Merged Document Report

Application No.: PL8504

Plat of Roy Smith Plaza Block 1, Lot 8

**Preliminary Utility Map of
 Roy Smith Plaza
 Block 1, Lot 8**

Plat of Roy Smith Plaza Block 1, Lot 8

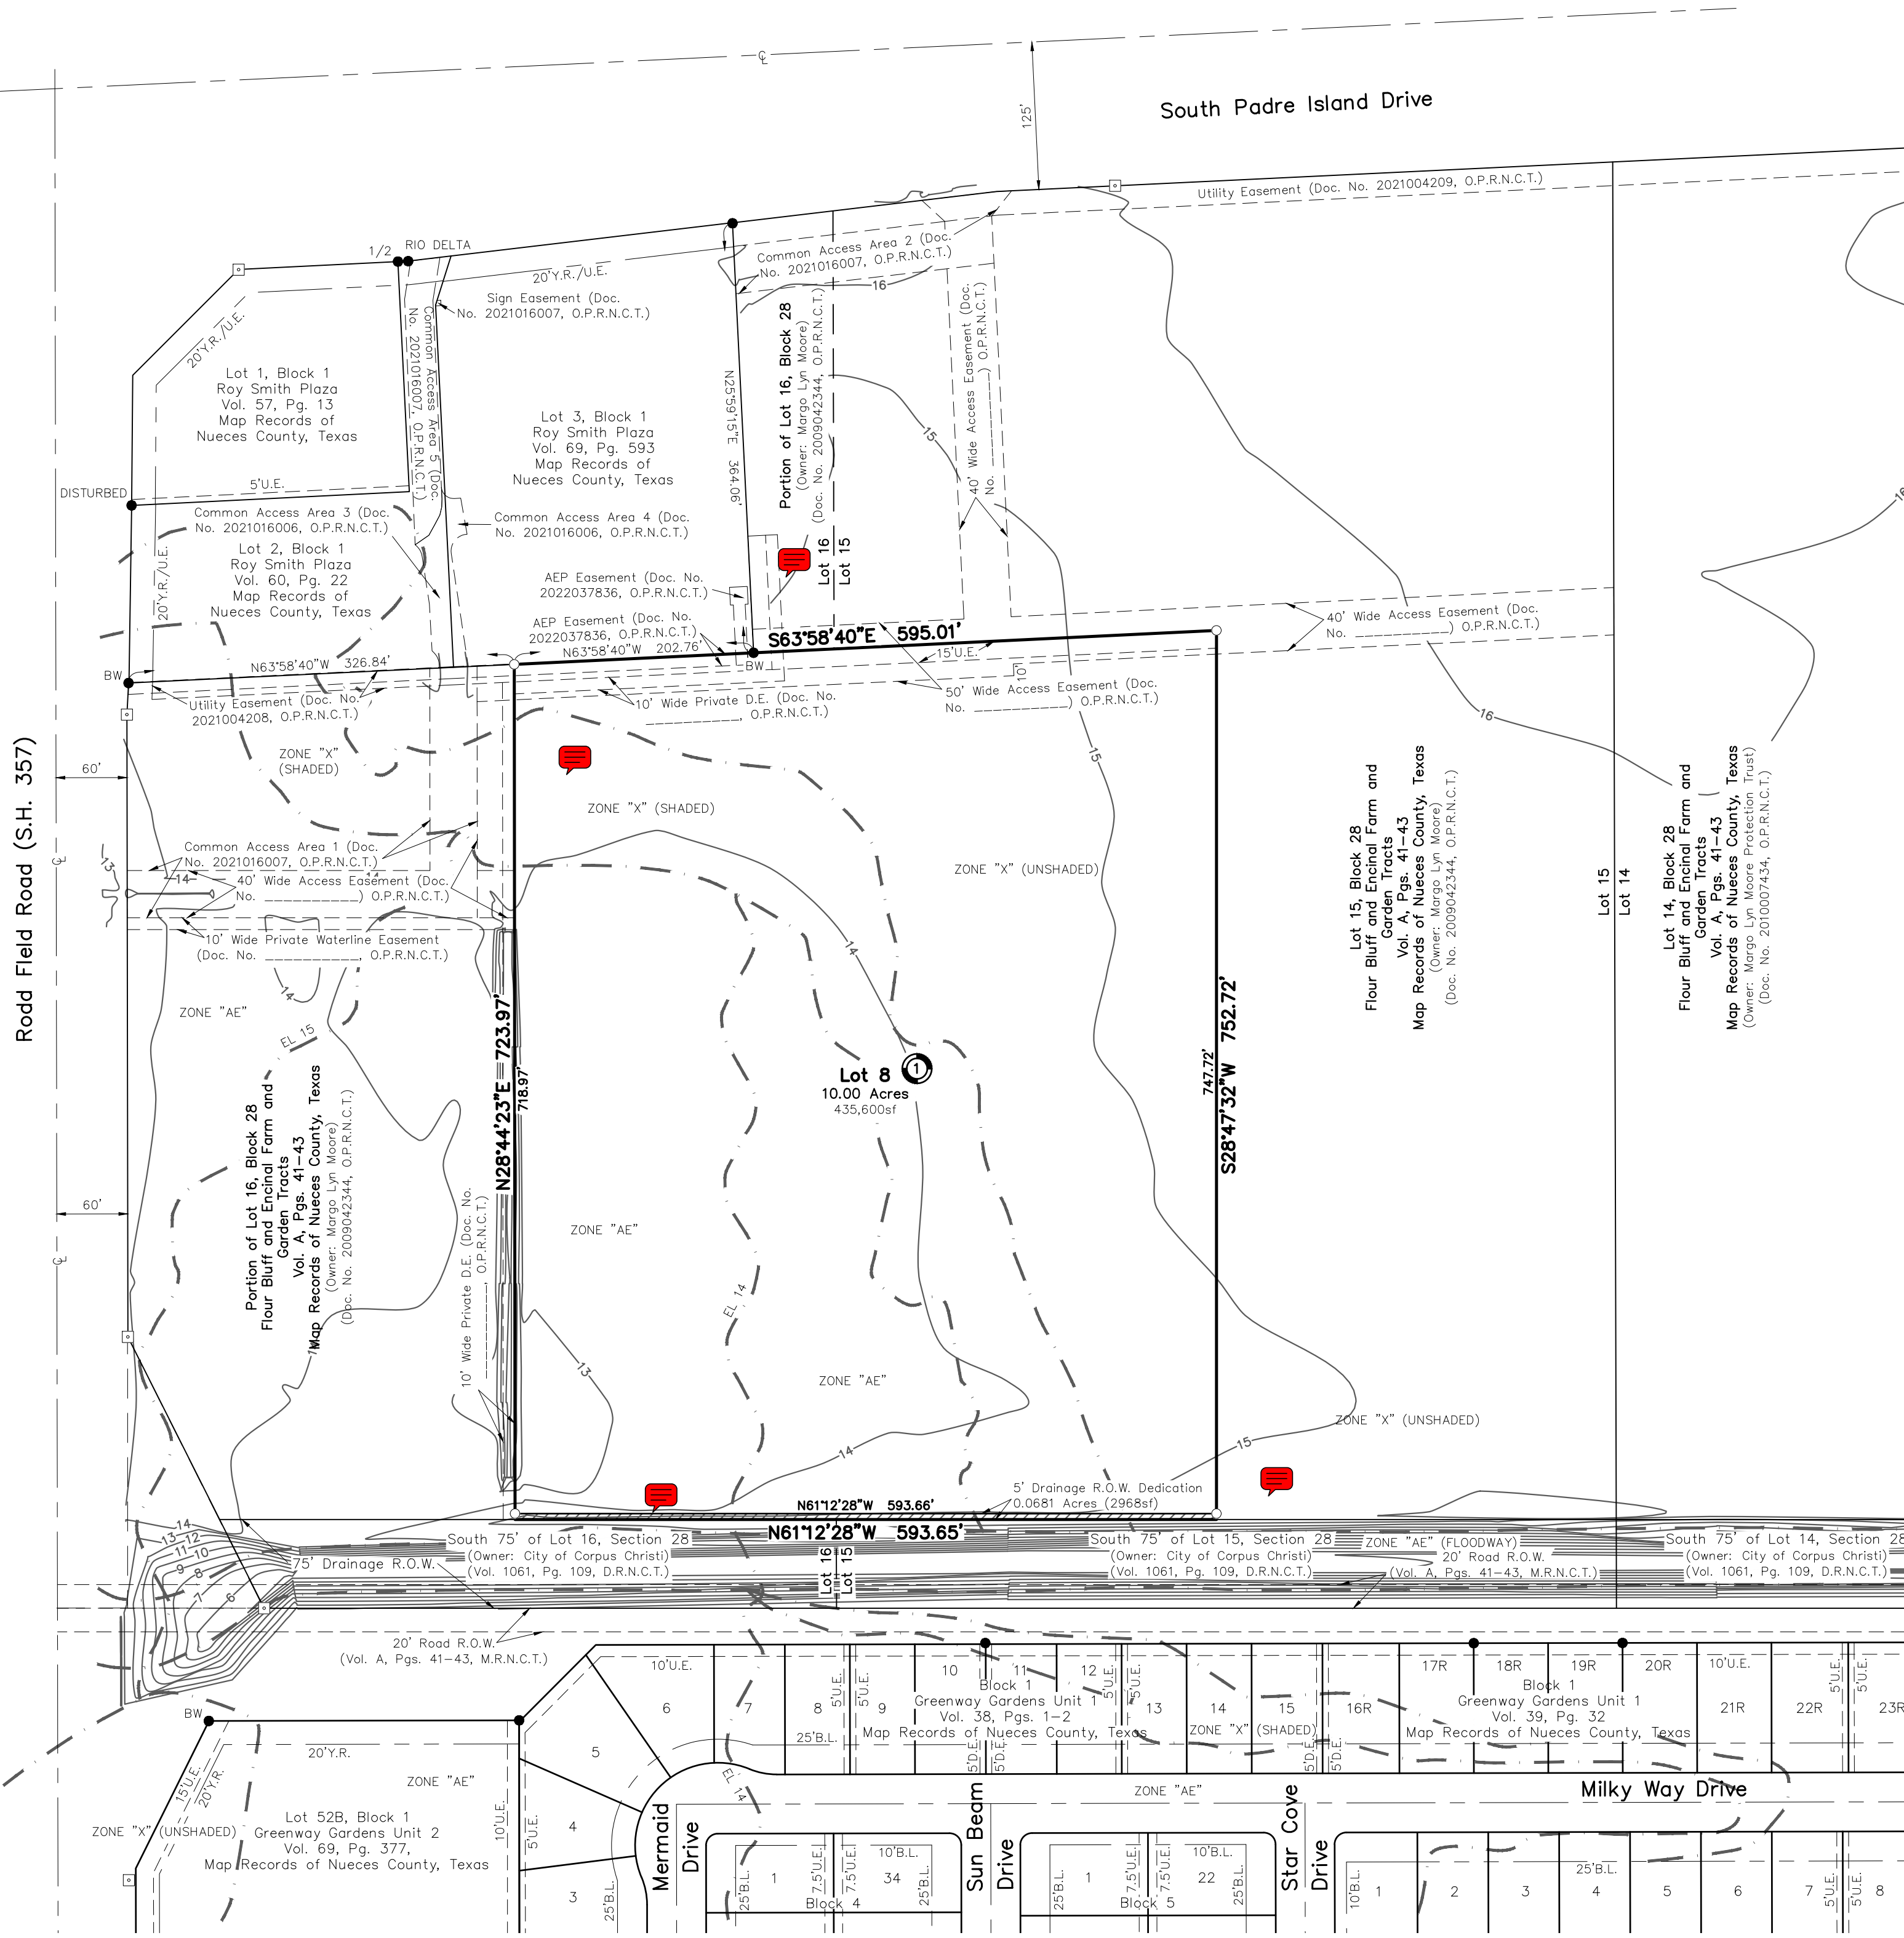
Comment ID	Page Reference	Annotation Type	Author : Department	Status	Review Comments	Applicant Response Comments
21	P001	Note	Melanie Barrera : DS	Open	PW-STW: Add as plat note, not just on SWQMP: During the development of the site, any increase in stormwater runoff flow rates must be mitigated in accordance with UDC 8.2.8.A, 8.2.8.B, and IDM 3.05 resulting in no adverse impacts between existing conditions and proposed conditions.	
11	P002	Note	Alex Harmon : DS	Open	Williams is identified as a Primary Collector (C3) street on the Urban Transportation Plan and is proposed to extend to the south of these lots from Rodd Field to Lexington. Show the typical crosssection for this street. Unless otherwise approved by the City and/or Director of Public Works.	
23	P002	Note	Melanie Barrera : DS	Open	PW-STW: Please confirm storm mitigation efforts will be privately maintained with a plat note.	
16	Utility Map	Note	Alex Harmon : DS	Open	Informational: Approval of a plat does not approve the layout of public utilities, including but not limited to water, wastewater, stormwater, SWQMP, and roadways. These items are only approved via Public Improvement Plans, which are required at time of final plat.

1	P001	Note	Mark Zans : LD	Open	<p>TxDOT comments- Please add the below 4 notes regarding access/drainage onto the state roadway system.</p> <ul style="list-style-type: none"> •No increase in stormwater discharge to the State right-of-way will be accepted by TxDOT. •TxDOT permits will be issued in accordance with access management standards and all applicable state and federal laws, including relevant rules and regulations. Considerations will include access connection spacing, materials, geometrics, accessibility, and other design specifications, as well as the impact on drainage and hydraulics, utility location or relocation, and environmental effects resulting from the requested construction of an access connection (43 Tex. Admin. Code §

Comment ID	Page Reference	Annotation Type	Author : Department	Status	Review Comments	Applicant Response Comments
					<p>11.52, 2020).</p> <ul style="list-style-type: none"> • Drainage improvements must accommodate runoff from the upstream drainage area in its anticipated maximum "build-out" or "fully developed" condition and should be designed to prevent overloading the capacity of the downstream drainage system. • If the owner responsible for maintaining the permanent stormwater or water quality control fails to maintain it to TxDOT ROW standards, the owner must rectify the issue. • Any development that anticipates an increase in existing traffic generation may be required to conduct a traffic study. The necessary improvements identified in the traffic study may need to be constructed by the developer, based on TxDOT's discretion and approval, prior to the access connection being established

2	P001	Note	Mark Zans : LD	Open	Plat is a Final plat.	
3	P001	Note	Mark Zans : LD	Open	This plat is on the 30-day tract for approval, approval with Conditions, or disapproval by 11/13/2024. The deadline for revisions to be submitted is 11/4/2024	
4	P001	Note	Mark Zans : LD	Open	The plat will be recommended as Conditional Approval for Resolution comments received and that have remained Open and unmet.	
5	P001	Note	Mark Zans : LD	Open	A request or response may be made for an additional 30 days for Public Notice plat with a Waiver or to resolve Open comments. This request must be made directly to Development Services within the 30-day initial period.	
6	P001	Note	Mark Zans : LD	Open	<p>Fire comments 1-9:</p> <p>1 Plat Note: All code reference is based on currently adopted International Fire Code (IFC) 2021 and Corpus Christi Water Distribution Standards.</p> <p>2 Plat "Commercial Development shall have a fire flow of 1,500 GPM with 20 psi residual Fire hydrant every 300 feet and operational."</p> <p>3 Plat 507.5.1 (amendment) Where Required: All premises, other than one-family detached dwellings, where buildings or portions of buildings are located more than 150 feet from a fire hydrant shall be provided with approved on-site hydrants and water mains capable of supplying the fire flow require by the fire official. The minimum arrangement being so as to have a hydrant available for distribution of hose to any portion of</p>

Comment ID	Page Reference	Annotation Type	Author : Department	Status	Review Comments	Applicant Response Comments
					<p>building on the premises at distances not exceeding 300 feet. Exception: For buildings equipped with an approved automatic sprinkler system, the distance requirement shall be 500 feet.</p> <p>4 Plat 507.5.4 Obstruction. Unobstructed access to fire hydrants shall be maintained at all times. The fire department shall not be deterred or hindered from gaining immediate access to fire protection equipment or fire hydrants. Note: Hose lay from a hydrant will not cross an arterial street.</p> <p>5 Plat 912.2.3 (amendment) Proximity to Hydrant: Fire department connections (FDC) for each sprinkler system or standpipe system shall be located not more than 100 feet from the nearest fire hydrant connected to an approved water</p> <p>6 Plat 503.1.1 (amendment) Buildings and facilities: Approved fire apparatus access roads shall be provided for every facility, building, or portion of a building hereafter constructed or moved into or within the jurisdiction. The fire apparatus access road shall allow access to three (3) sides of buildings in excess of fifteen thousand (15,000) square feet and all sides for buildings in excess of thirty thousand (30,000) square feet.</p> <p>7 Plat 3310.1 Required access. Approved vehicle access for firefighting shall be provided to all construction or demolition sites. Vehicle access shall be provided to within 100 feet of temporary or permanent fire department connections. Vehicle access shall be provided by either temporary or permanent roads, capable of supporting vehicle loading under all weather conditions. Vehicle access shall be maintained until permanent fire apparatus access roads are available.</p> <p>8 Plat D102.1 Access and loading. Facilities, buildings, or portions of buildings hereafter constructed shall be accessible to fire department apparatus by way of an approved fire apparatus access road with an asphalt, concrete or other approved driving surface capable of supporting the imposed load of fire apparatus weighing at least 75,000 pounds.</p> <p>9 Plat 503.1.1 (amendment) Buildings and facilities: During construction, when combustibles are brought on to the site in such quantities as deemed hazardous by the fire official, access roads and a suitable temporary supply of water acceptable the fire department shall be provided and maintained.</p>

7	P001	Note	Mark Zans : LD	Open	Fire comments 10-18

Comment ID	Page Reference	Annotation Type	Author : Department	Status	Review Comments	Applicant Response Comments
					<p>10 Plat 503.2.1 Dimensions. Fire apparatus access roads shall have an unobstructed width of not less than 20 feet, exclusive of shoulders and an unobstructed vertical clearance of not less than 13 feet 6 inches.</p> <p>11 Plat D103.1 Access road width with a hydrant. Where a fire hydrant is located on a fire apparatus access road, the minimum road width shall be 26 feet, exclusive of shoulders.</p> <p>12 Plat "The minimum required width of 20 feet that shall be maintained means a clear unobstructed path that allows the passage of fire apparatus.</p> <p>1. Where Fire Apparatus Access is constructed to the minimum of 20 feet, no parking is allowed within the fire apparatus lane.</p> <p>2. Where a fire hydrant is located on the street, the minimum unobstructed clearance shall be 26 feet. In this instance, no parking is allowed on one side of the street.</p> <p>3. The minimum UDC residential street width is 28 ft. curb to curb. Any parking along the street that reduces the width to less than 20 ft. is prohibited and the Fire Code Official and will require painting "NO PARKING-FIRE LANE" along one side of the street."</p> <p>13 Infor. "Note: Calculated Turning Radii for Fire Apparatus: Inside Turn: 20 ft. 3 in. Curb to curb: 36 ft. 8 in. Wall to wall: 44 ft. 8 in."</p> <p>14 Plat 503.4 Obstruction of fire apparatus access roads. Fire apparatus access roads shall not be obstructed in any manner, including the parking of vehicles. The minimum widths and clearances established in sections D103 shall always be maintained.</p> <p>15 Plat 503.3 Marking: Where required by the fire code official, approved signs, or other approved notices the include the words NO PARKING-FIRE LANE shall be provided for fire apparatus access roads to identify such roads to prohibit the obstruction thereof. The designation of a fire lane can be marked with conspicuous signs which have the words:" Fire Lane-No Parking" at 50-foot intervals. In lieu of signs, fire lanes may be marked along curbing with the wording, "Fire Lane-No Parking" at 15-foot intervals.</p>

Comment ID	Page Reference	Annotation Type	Author : Department	Status	Review Comments	Applicant Response Comments
					<p>16 Plat Table D103.4 Requirements for Dead-end fire apparatus access roads. Turnaround provisions shall be provided with a 96-foot diameter cul-de-sac.</p> <p>17 Plat 503.2.5 Dead ends. Dead-end fire apparatus access roads more than 150 feet in length shall be provided with an approved area for turning around fire apparatus.</p> <p>18 Plat Commercial development of the property will require further Development Services review.</p>	
9	P001	Callout	Mark Zans : LD	Open	Remove Al Raymond name. Insert Michael Dice Interim Director	
20	P001	Note	Mark Zans : LD	Open	As of this date (11/1/2024) many of the open comments from the preliminary plat still apply with this plat. Please check the merged document report from preliminary plat application that are open comments.	
8	P002	Note	Mark Zans : LD	Open	Provide doc. numbers for DE, AE, and UE for the easements shown.

**Preliminary Utility Map of
 Roy Smith Plaza
 Block 1, Lot 8**

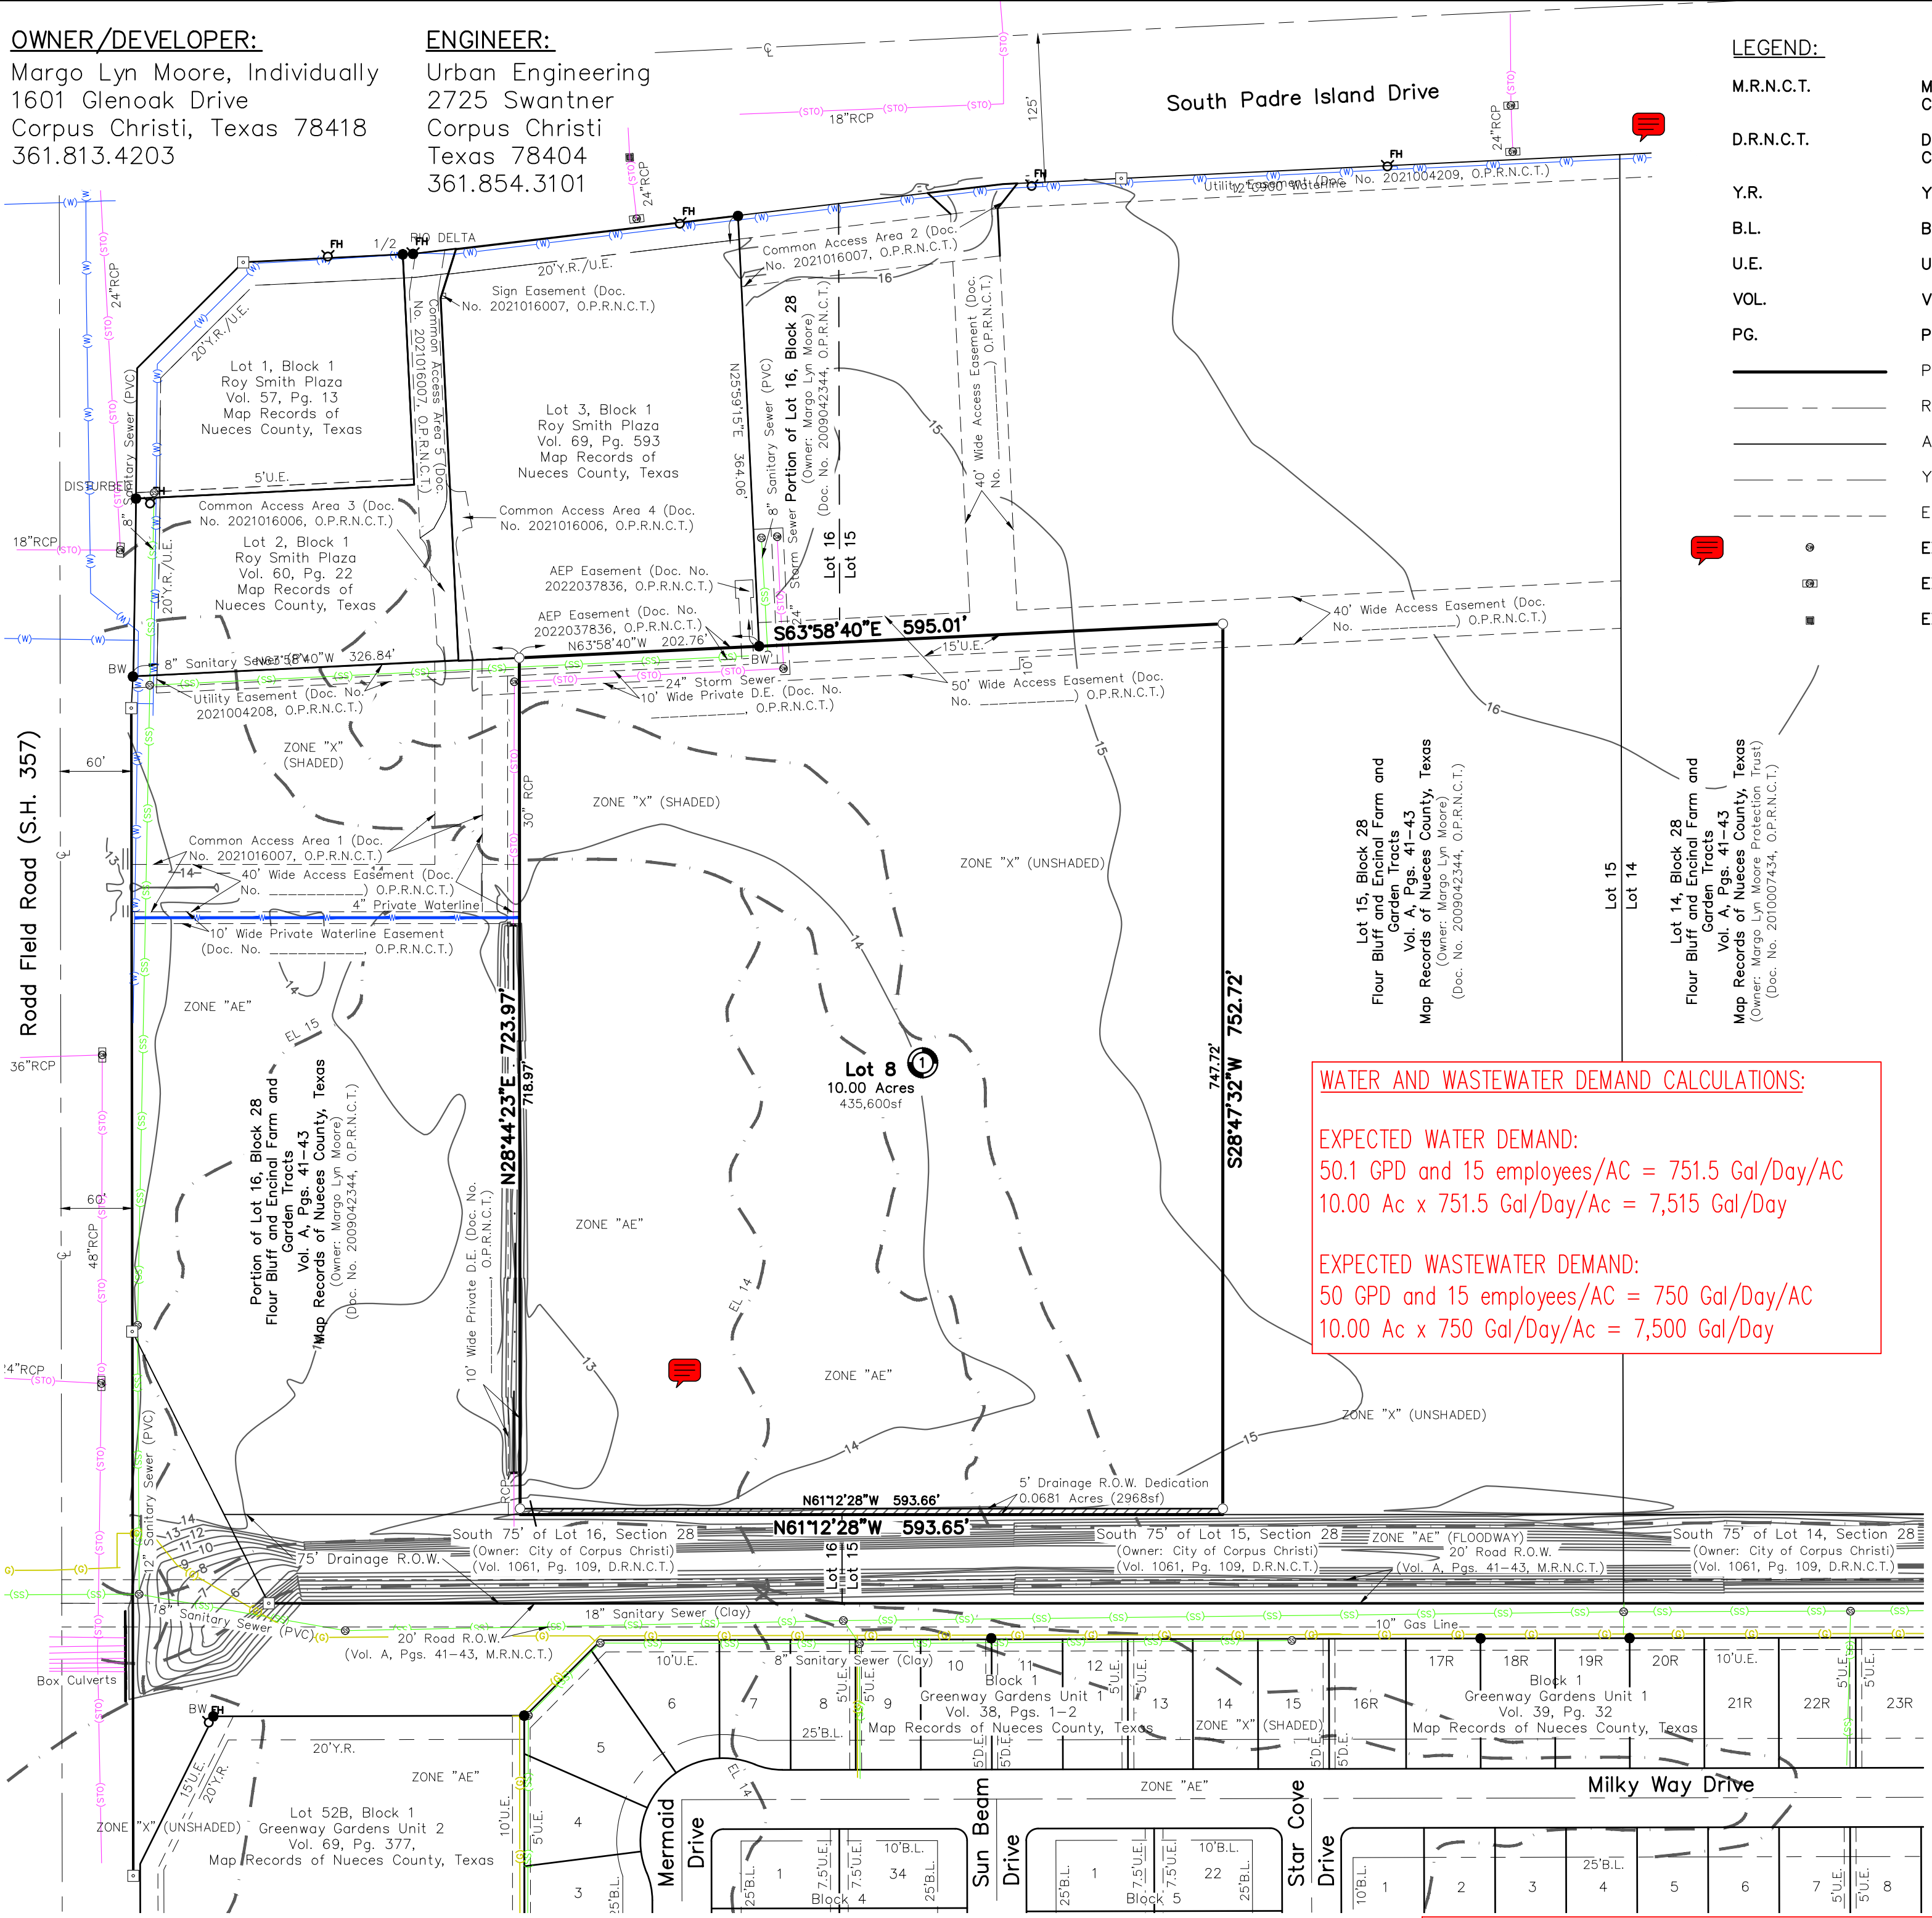
18	Utility Map	Note	Alex Harmon : DS	Open	Per UDC 8.1.5., All required improvements shall be designed and installed in order to provide for a system of utilities, storm water and streets and to create continuity of improvements among adjacent properties. Has consideration been given to how Lot 9 will receive water and wastewater?
